**Re : EB-2022-0024 – Elexicon Energy Inc. (“Elexicon”) ICM  
Application (the “Application”): Phase 2 Responses to OEB Panel Questions**

Pursuant to the provisions established in Procedural Order No. 4 (“P.O. #4”), issued on February 8, 2023, Elexicon is filing its responses to Additional Question #1 provided in P.O. #4, and responses to the additional four OEB Panel questions issued on February 10, 2023.

Answer to OEB Commissioner's Questions

OEB PANEL – 1  
ATTACHMENT 1  
MAP ILLUSTRATING OPTION 1

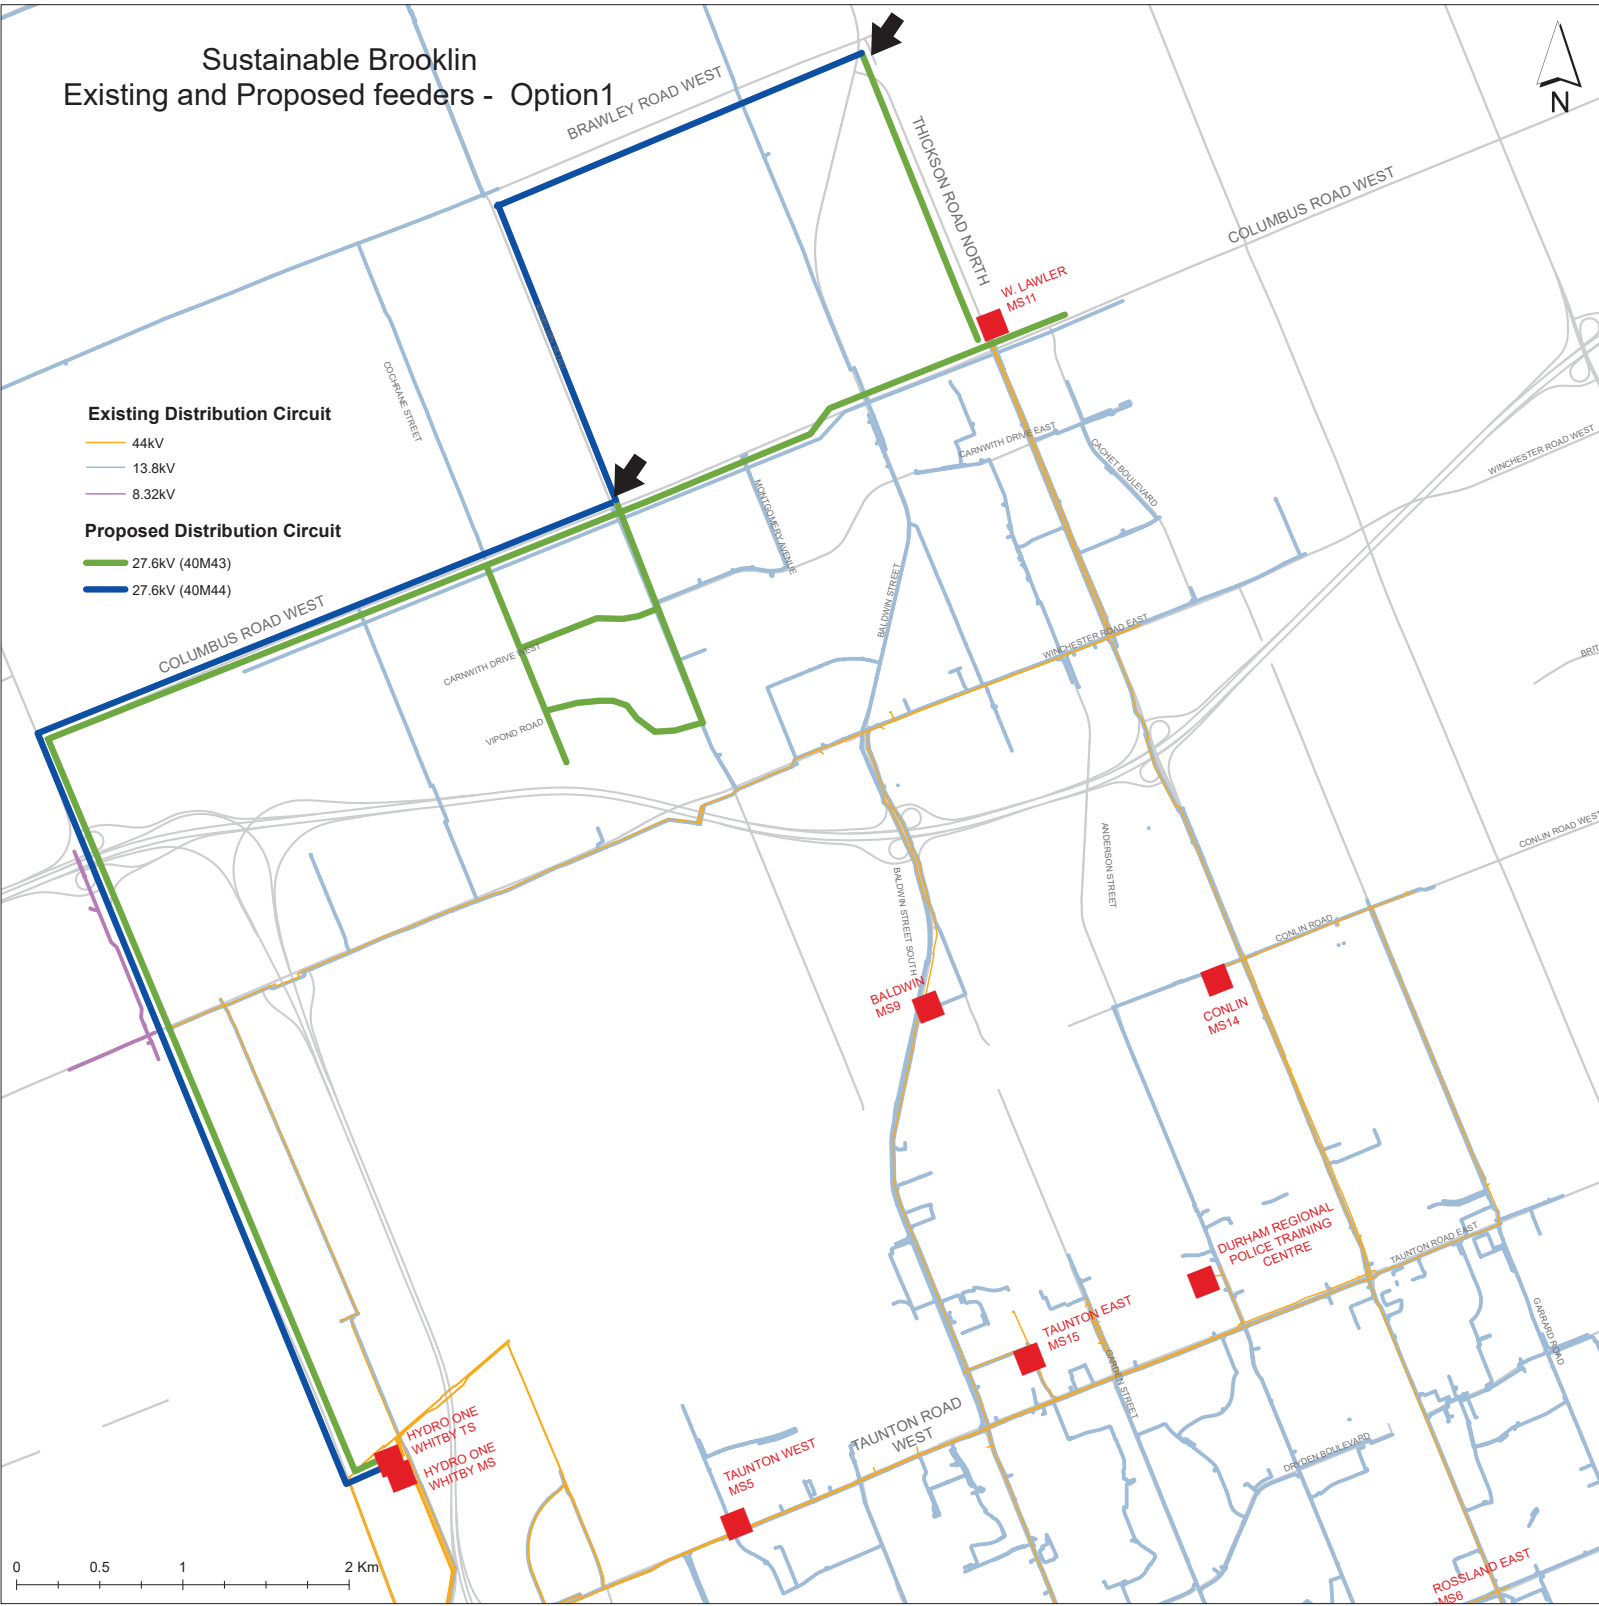
Please provide a map clearly illustrating options 1, 3 and 4 in Appendix B-2 commencing at the Whitby TS that includes major roads in the area, existing and proposed feeders and voltages, the step-down equipment location, and the location of the Sustainable Brooklin project (Phase 2) as illustrated in reference 2. Please clearly illustrate the existing distribution circuits by kV size and options 1, 3 and 4 in separate colours."

Option 1: Build two 27.6kV feeders and the associated assets from the last two available breakers at Whitby transformer station ("TS") all the way to the intersection of Columbus Road West and Ashburn Road. The total distance of one feeder is about 10 km. There is currently no pole line on Lake Ridge Road from the Whitby TS to Highway 7/Winchester Road, Elexicon has a three phase 8.32kV circuit from Highway 7 to Highway 407 and three phase 13.8kV circuit from Coronation Road to Ashburn Road.

See Attachment 1 accompanying this response for a map illustrating this option.

OEB PANEL – 2  
ATTACHMENT 1  
TOWN OF WHITBY  
COMPREHENSIVE BLOCK PLAN

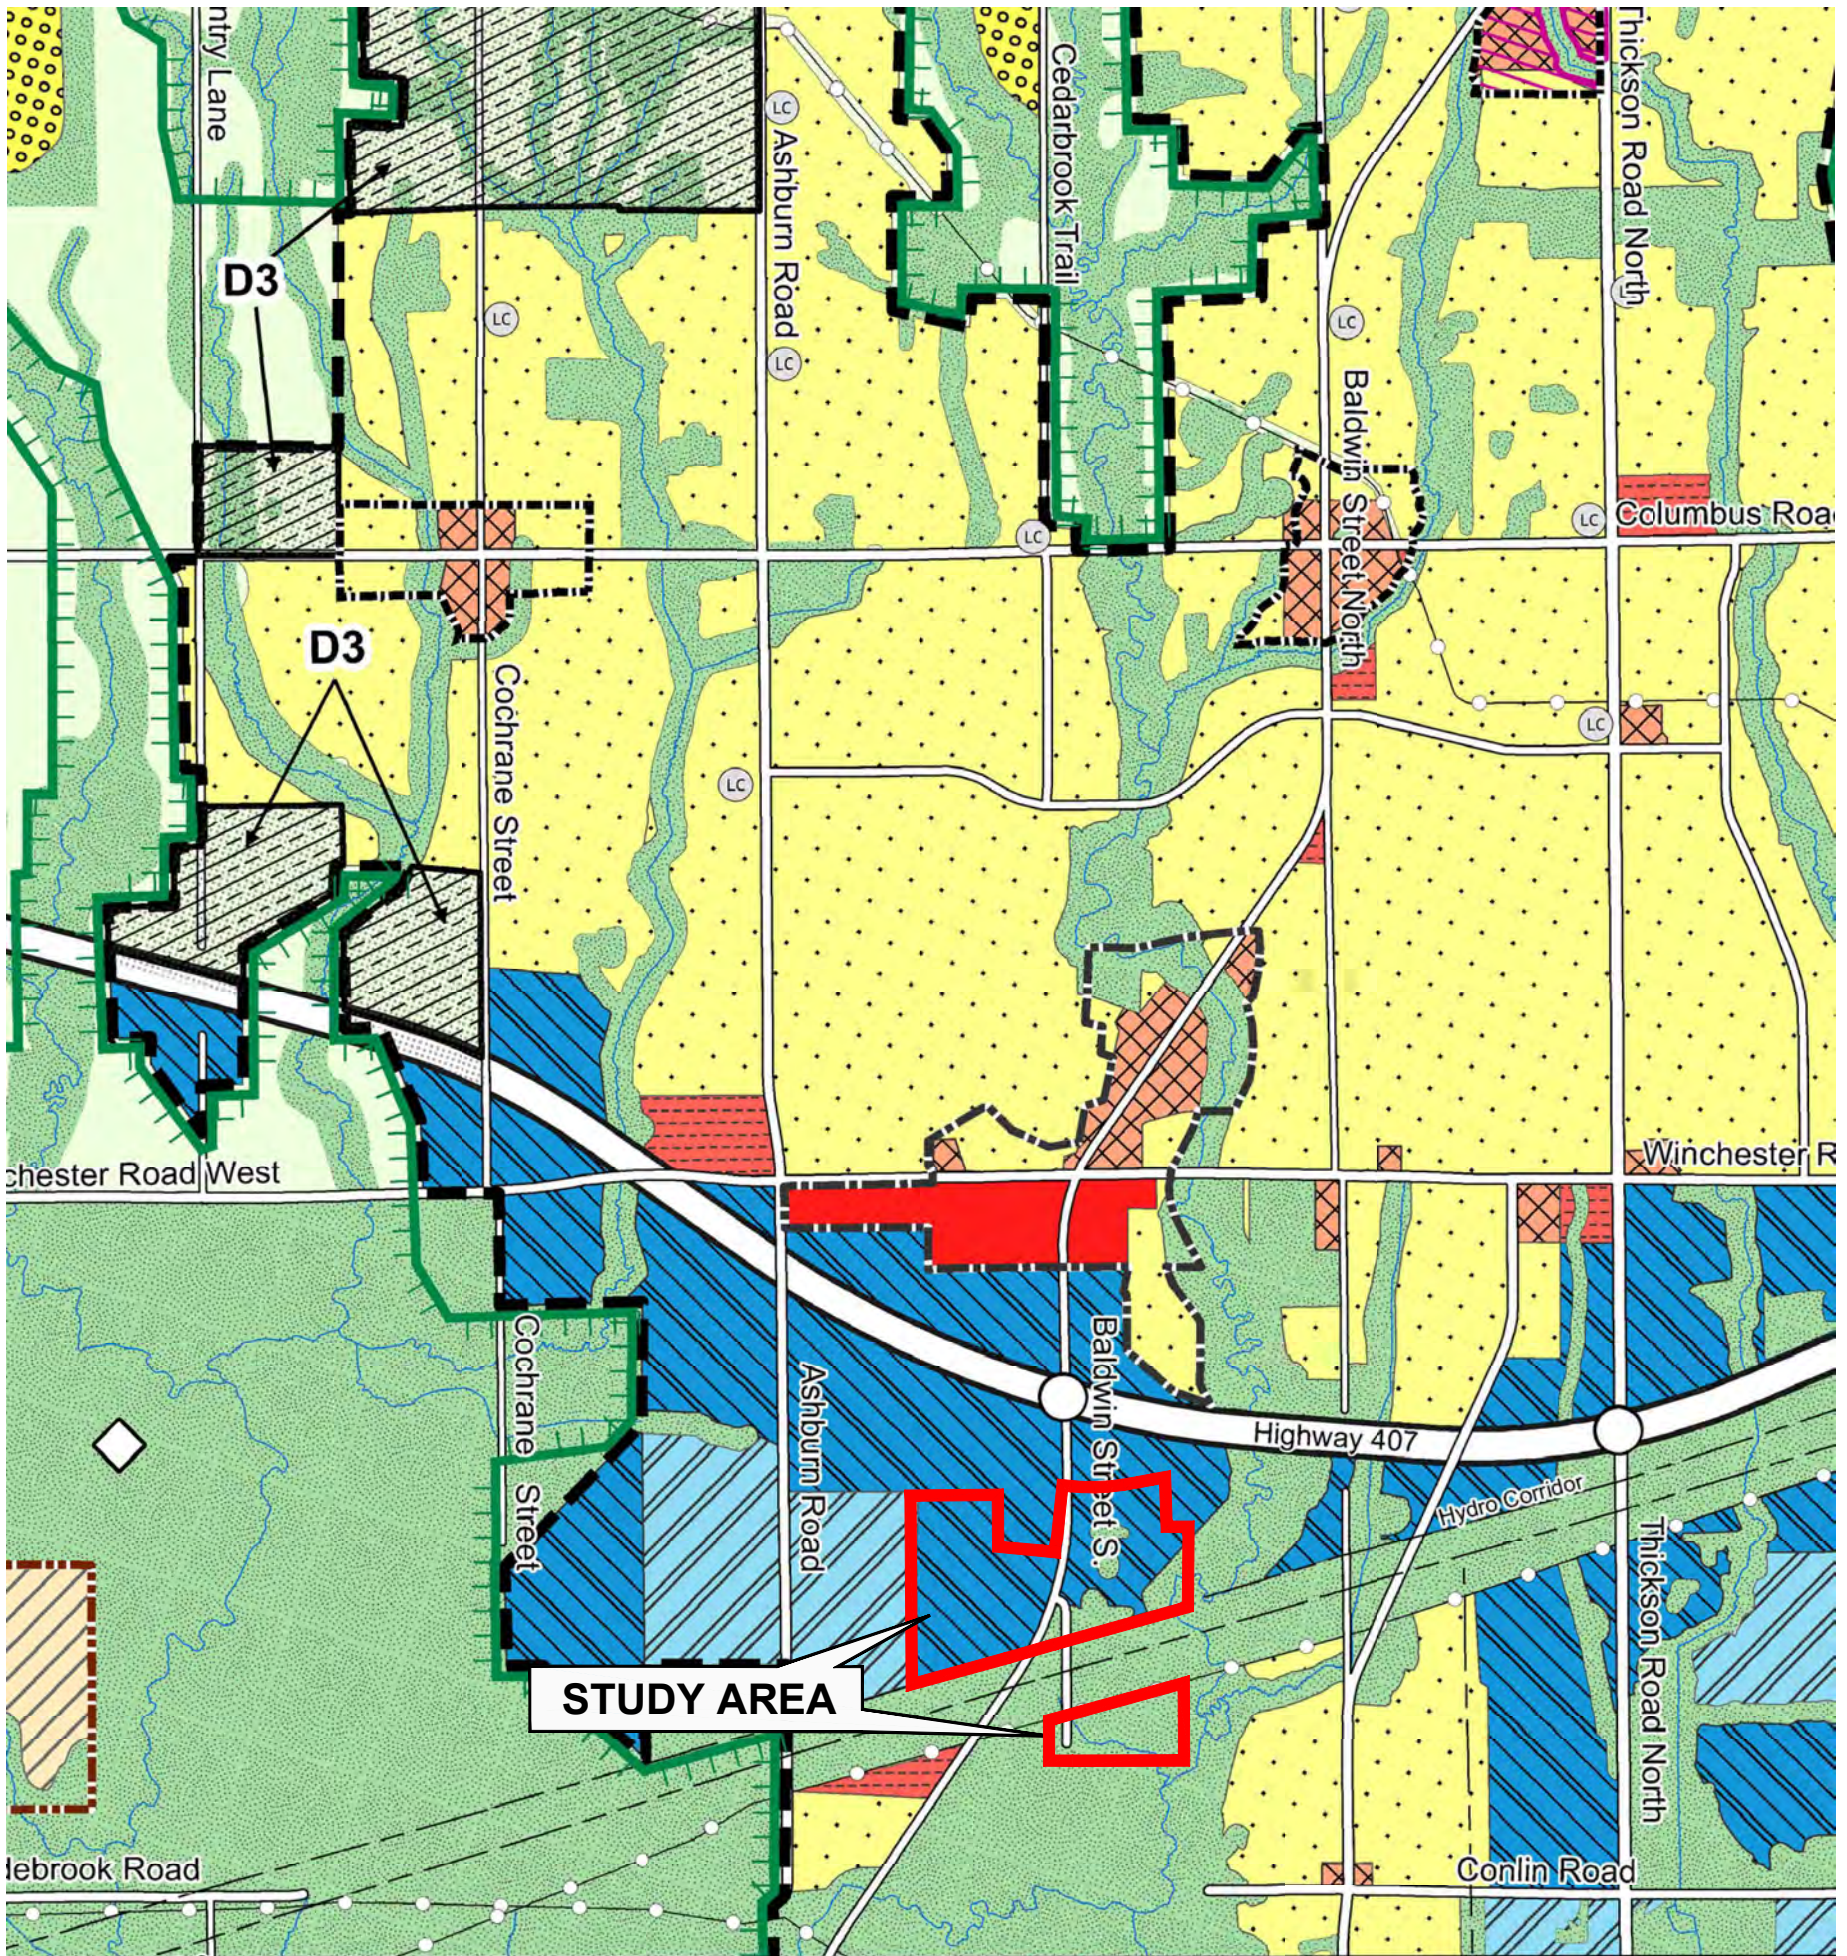
g) Elexicon Energy indicated that it rejected option 3, utilizing an existing 44 kV line reserved for commercial and industrial growth, to serve the Sustainable Brooklin project. Please provide a list of all contracted demand or forecast demand in 2023 and 2024 to be served by this 44 kV line and provide the remaining capacity to serve the Brooklin Landowners. Is Elexicon Energy indicating that it is uneconomic to step down the 44 kV line to 27.6 kV, to match the voltage of the proposed option 1?

Elexicon energy does not believe there is economic benefit in stepping down the voltage from 44kV to 27.6kV to match the voltage in Option 1, as doing this will eventually increase overall costs. In addition to the cost of building 44kV feeders to North Brooklin, which will cost more than building a 27.6 KV line, Elexicon will still need to step down the voltage to supply residential customers. The current estimate to build a step-down station from 44kV to 13.8kV with two transformers is around \$9M excluding the cost of land.

Elexicon’s planning team is responsible for power system planning to accommodate a range of new customer growth across its *entire* service area. Knowing all the potential commercial and industrial demand projected in the Whitby area south of highway 407 from Ashburn to the Oshawa border (Known as the Mid-Block Arterial Road development), Elexicon has decided to use the 44kV voltage to supply that load, since the demand is substantive in nature and therefore requires large capacity feeders. In all situations, customers will be responsible to step-down the voltage locally using private substations. In addition to the 44kV feeders being built to supply power to the new commercial and industrial customers, they will provide flexibility and backup to the existing 44kV system in North Whitby; this was one of the reasons Elexicon could not supply North Brooklin from the 44kV system in the area.

Attachment 1 is a map showing the Town of Whitby’s comprehensive plan for the area south of highway 407.
